From: Holloway, Andrew
Sent: Tuesday, October 7, 2025 9:30 AM
To: Knapp, Kenneth; Caudill, Ethan; Fisher, Don
Cc: Mellen, Adam; Baker, Jared; Alford, Jennifer
Subject: RE: 112691-LOR-20/301

This meeting is to discuss roadside safety options surrounding PID: 112691, Elyria urban paving?

Figure 219. Recommended placement of MGS behind curb, 31-in.-tall relative to curb/soil.

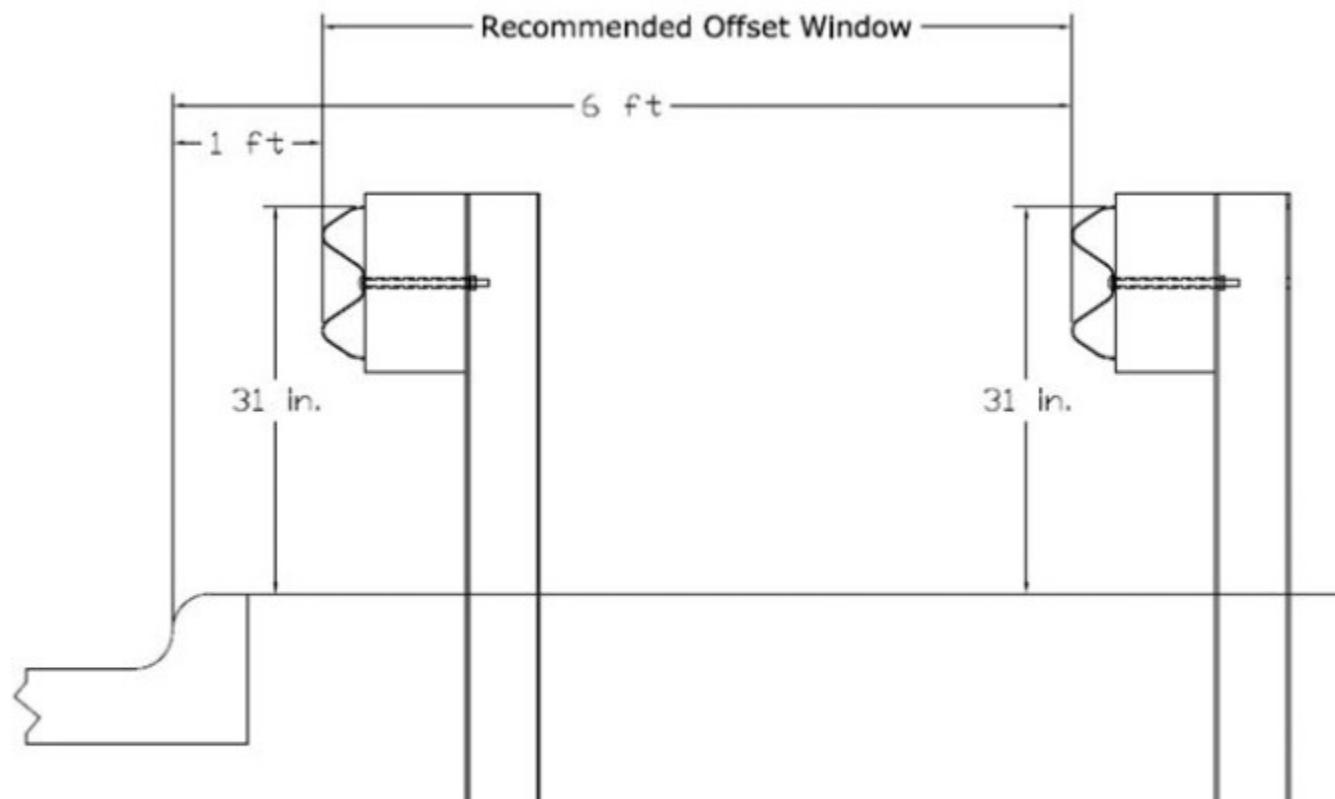
- After running simulations on a variety of MGS to curb offsets, NCHRP 1089 ran test 3-11 (pickup truck, 62mph, 25 degrees) on MGS at a 6' offset from a 6" curb and test 3-10 (passenger car, 62mph, 25 degrees) at a 1' offset from a 6" curb. These tests were deemed critical to evaluate the potential for pickup truck override at larger offsets and small car underride or snagging at lesser offsets.
 - Both tests passed MASH 2016 criteria
- The study identified through simulation efforts that curbs with a shorter height or more traversable shape will result in a reduction in vertical trajectory and therefore can be used in lieu of the 6" curb.
- Testing was done on level terrain. A 10:1 approach slope for 6' would result in a 7" reduction in elevation of the rail, which would increase the potential for override.

ORE has not updated L&D1 to reflect the new research from NCHRP 1089, but we plan to with the July 2026 update. For now, the table/details below can be used and referenced. Note that the 31" is relative to the top of curb for 1'-6' offsets. Additionally, it is important to keep the approach slopes as flat as possible when offsetting MGS behind curb. I placed a copy of NCHRP 1089 here if needed:

Lateral Offset (face of curb to face of rail)	MGS Installation Height
≤ 0.5 ft	31 in. relative to roadway surface
1 ft–6 ft	31 in. relative to top of curb/soil backfill
> 6 ft	Not recommended; further analysis required
